# FOR THE PROPOSED CONSTRUCTION AND OPERATION OF A CONSOLIDATED FUELS FACILITY AND THE DEMOLITION OF THE EXISTING FUEL FARM AT BUCKLEY AIR FORCE BASE, COLORADO

- e. **Designation**: Draft Environmental Assessment (EA)
- f. **Abstract**: The purpose of the proposed action is to meet the fuel storage and distribution requirements at BAFB and to reduce air pollution from the existing facilities while adding the equipment necessary for using alternative fuels at BAFB. The need for the proposed action arises because the existing fuel tank farm is deteriorating and requires on-going repairs. The tank farm is also currently located in an incompatible land use area. Additionally, fuel trucks for aircraft operations must travel across the base from the aircraft apron and back, which creates safety concerns associated with the transportation of highly flammable materials on a regular basis. In addition to the proposed action, four alternatives were analyzed, including the no action alternative, two alternative locations, and upgrading the existing facility.

Figure 2-1. Proposed Consolidated Fuels Facility on Buckley AFB

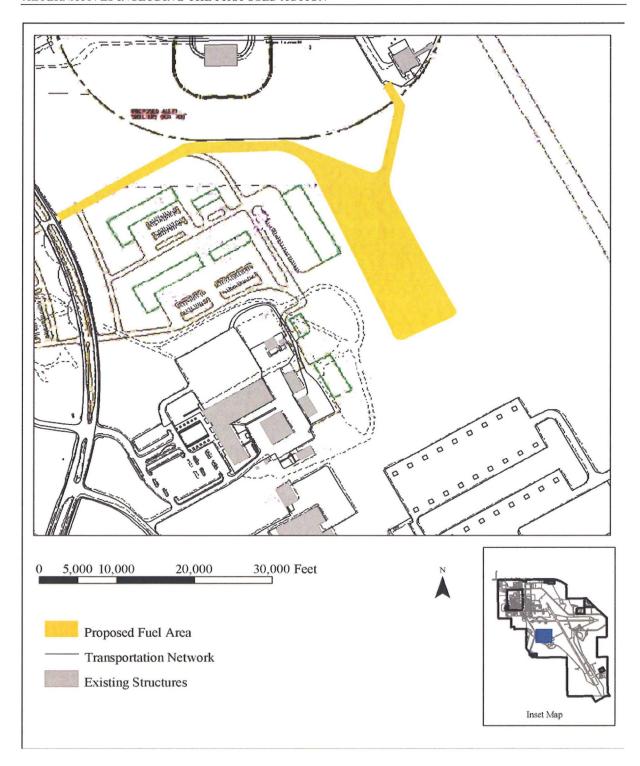
- 1) Figure 2-1 indicates an access road from Aspen Avenue to the proposed action (new Fuels Facility). This is potentially in the downrange footprint of the former skeet range and this EA should discuss this.

The MMRP is another program category under the Air Force ERP. The scope of the MMRP is investigation and cleanup of other-than operational ranges contaminated with military munitions, e.g., unexploded ordnance, or chemical residues of munitions. Buckley currently has two MMRP sites, an abandoned outdoor range and a former skeet range, illustrated in Figure 2-1. Note that the former skeet range is in the downrange footprint to several alternative actions. The Air Force MMRP is centrally managed by Air Staff, which recently initiated a Comprehensive Site Evaluation, Phase I, at each base to identify additional MMRP sites that may require responses to protect human health and the environment.
